MEMORANDUM

COMPANY:	Rix's Creek Pty Limited		
ATTENTION:	John Hindmarsh		
FROM:	RPS Water		
DATE:	23 March 2016	JOB NO: WS00066E	DOC NO: 005c
SUBJECT:	Rix's Creek EIS - Supplementary Groundwater Information

This document provides supplementary groundwater information in response to the DPI Water submission on the Rix's Creek Continuation of Mining Environmental Impact Statement.

Figure 1 : Location of Calibration Targets (Local to Site)

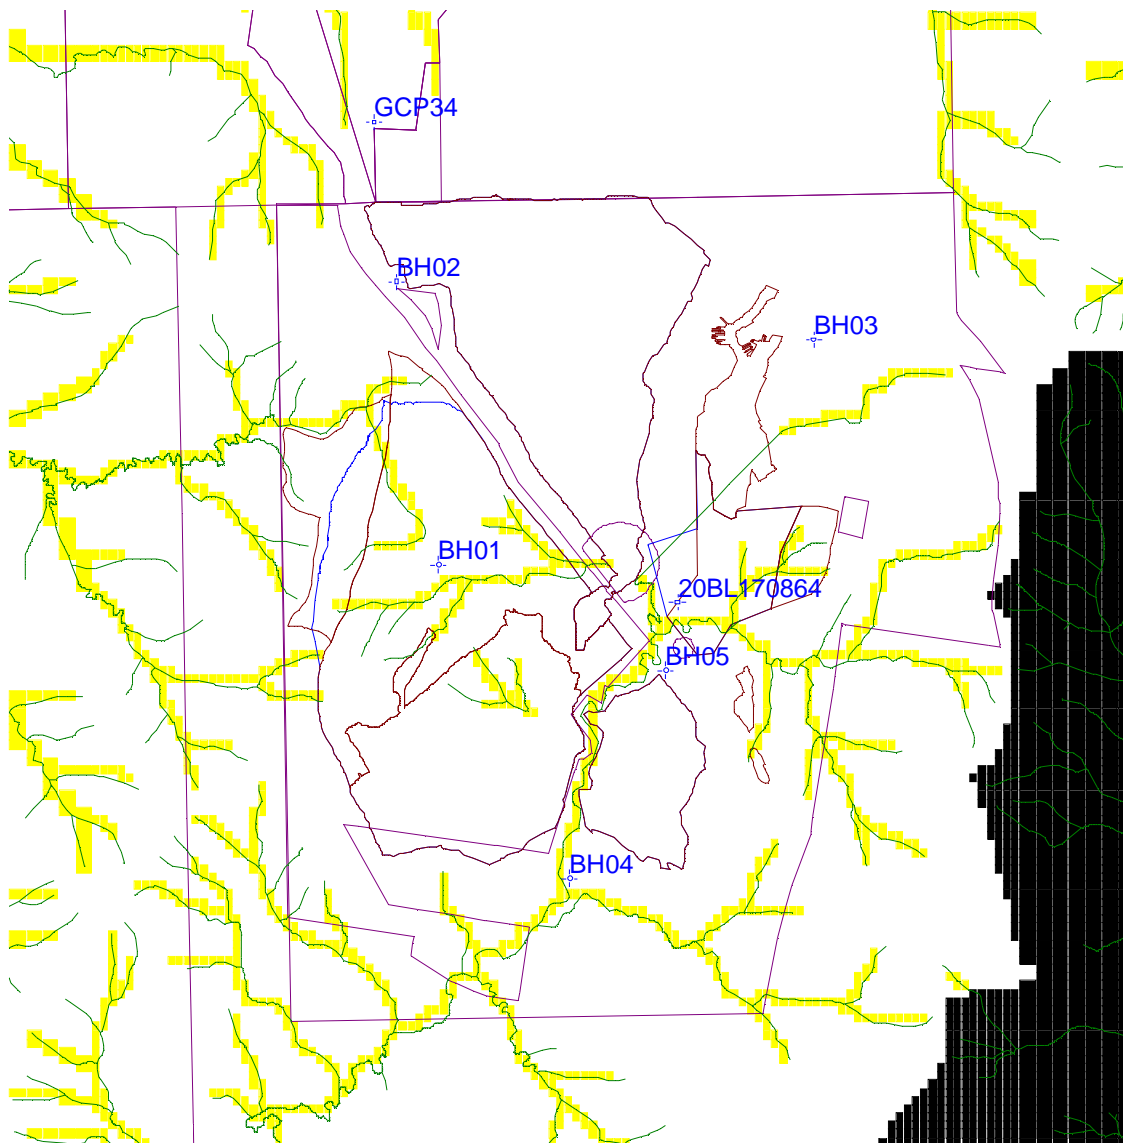
Issues	Response	Outcomes from Site Meeting – 21/01/16 (RPS)	Additional Information
	west.		
8. The calibration dataset type should be better described and it is unclear where the calibration points are situated as no legible map has been provided.	agreed	Provide map and description of calibration dataset.	Refer to supplementary groundwater information

The location of model calibration targets is presented in Figure 8.14.6 to 8.14.8 of RPS (2014) with respect to each layer. **Figure 1** below presents the same information, however, with all targets local to the site, presented on a single figure, regardless of which model layer they reside in. It is highlighted that the scale of the model domain is large so as to account for potential cumulative impact from the adjacent mining operations to the north, northwest and far southwest as well as the Hunter River.

Figure 5 : Modelled Groundwater Elevation (mAHD) (Layer 11, April 2014 (SP185TS5)) – Current Calibration Model (RPS Run # 015a_CAL-Apr14_07a.gww)

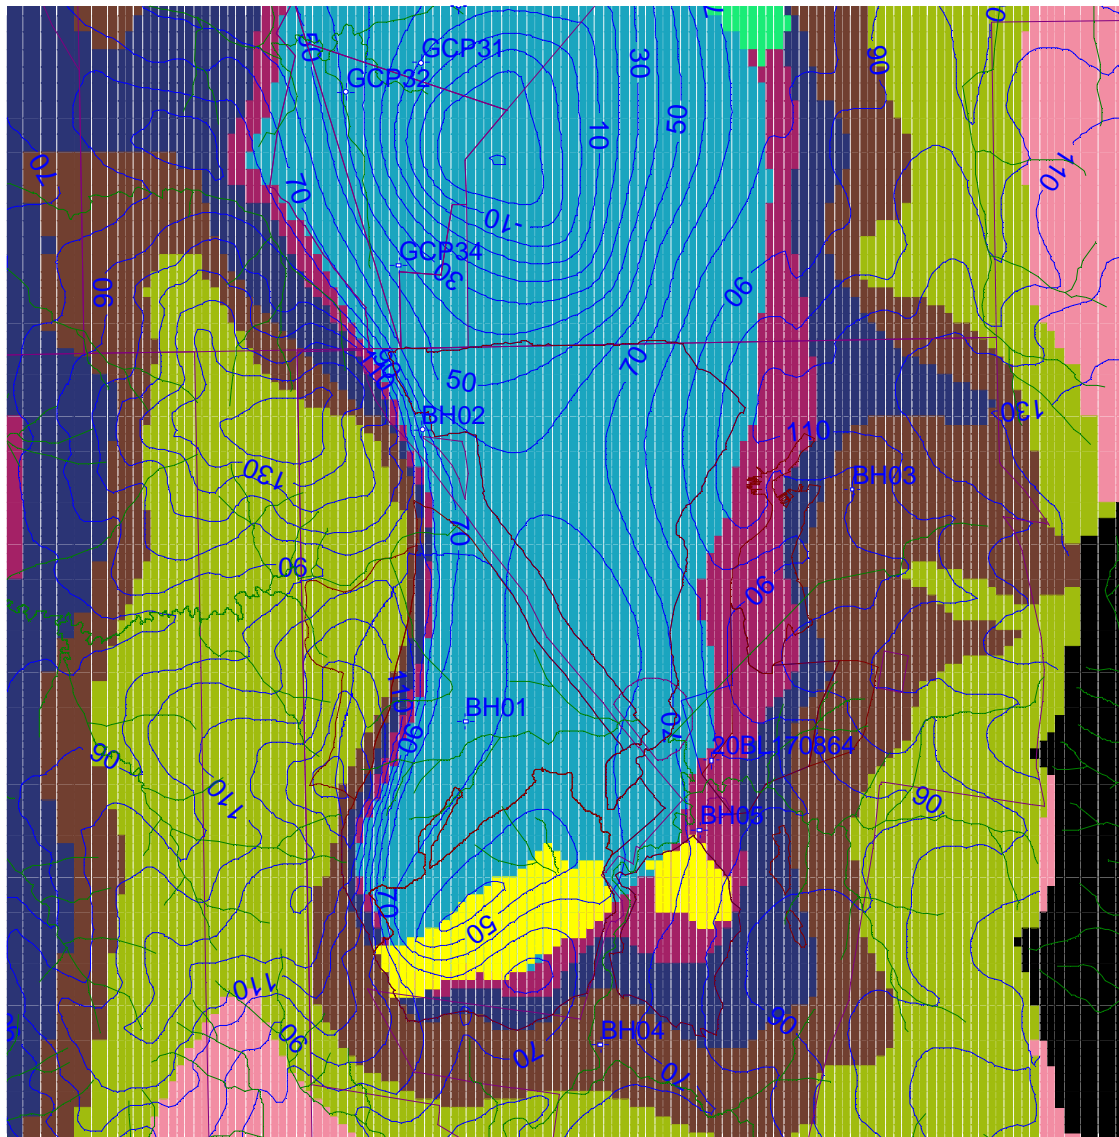
Issues	Response	Outcomes from Site Meeting – 21/01/16 (RPS)	Additional Information
	Agreed – output figures are poorly presented and units are missing.		
<p>2. The model was not calibrated. A scaled root mean squared error (SRMS) of 16% was achieved. The Australian Groundwater Modelling Guideline recommends ~10%. The calibration hydrographs were not legible so no analysis of the calibration was performed by DPI Water.</p>	<p>The model is calibrated and has an SRMS error of 16% as reported. This could have been improved by “disregarding” unfavorable calibration points that skew the results, however it was decided to keep in all available data.</p> <p>It should also be noted that by only utilizing data points within the syncline the calibration statistics would also have been improved.</p> <p>Mismatches in predicted versus observed values are typically the result of other localised stresses that are not included in the model.</p> <p>Agreed hydrographs are not clearly presented.</p> <p>Aside from the SRMS the model water balance was sound and provided reasonable results.</p> <p>For the potential risks posed by the development the calibration was deemed to be sufficient.</p>	<p>Provide calibration statistics for local monitoring points only to eliminate unknown regional stresses.</p> <p>Previous version of model with closer boundaries had a calibration of 9.6% SRMS.</p>	<p>Refer to supplementary groundwater information</p>

Figure 5 presents the modelled contours of head (mAHD) in Layer 11 of the calibration model (RPS Run # 015a_CAL-Apr14_07a.gww), as at April 2014 (SP185TS5) together with the hydraulic conductivity zonation. It is noted that all calibration targets are displayed in **Figure 5** whereas, in the model, only target BH01 is located in Layer 11. Contour intervals presented in Layer 11 are 10m increment and the boundary condition (DRN cells) at the relevant timestep are displayed in yellow. As presented in RPS (2014), Section 8.5.5, DRN cells were used to represent progression of the open cut mine, based on mine landform surfaces (approximately 2 yearly during the calibration simulation).

From **Figure 5**, the influence of dewatering of the previous Integra operation and Pit 3 lead to development of a cone of depression with a north-south alignment. Target BH01 is located to the northwest of active mining area in Pit 3 and the drawdown is underestimated in the model. Target BH02 is located between Pit 3 and Pit 1, adjacent the hillside, where the local hydraulic gradient in the model is quite steep. As presented in RPS (2014), predicted impacts of continuation of mining at Rix's Creek are consistent with the conceptual hydrogeological model, namely hydrogeological impacts are constrained to the west, south and east due to outcropping of the various coal seams. **Figure 2** presents the hydrograph for monitoring location GCP34, which is located to the north of BH02. The fit to observation at GCP34, which is situated at the point where off-site impacts may propagate northward is closely matched.

Figure 7 : Groundwater Elevation Hydrograph (mAHD) – Current Calibration Model (RPS Run ID. 015a_CAL-Apr14_07a.gvw)

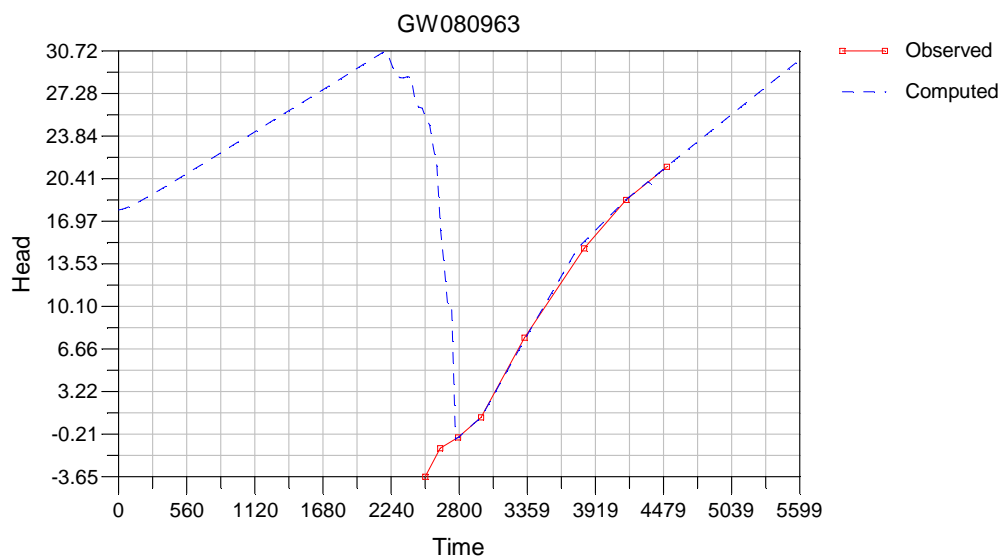
Issue DPI Model 07) A general head boundary condition was applied to layers 3 and 4 of the model based on a linear extrapolation from bore GW080963. A conductance of 100 m³/day was applied to this fixed head. This feature provides an infinite supply of water into the model and it is uncertain whether this approximation is hydrogeologically justifiable in representing the long-term impact of mining activity in the south-west corner of the model domain. The effects that the feature may have on the model domain in maintaining water level elevations is unknown without inspection of the model.

As stated in Section 8.5.4 of RPS (2014), the general head boundary was used to represent groundwater level history record at GW080963, which is located in the southwest corner of the model domain. The change in groundwater level at this location reflects the effect of Rio Tinto's Hunter Valley Operations site. **Figure 7** presents the modelled versus observed hydrograph at GW080963. To ameliorate the potential for an infinite supply of water to the model a general head boundary was used in place of a constant head boundary.
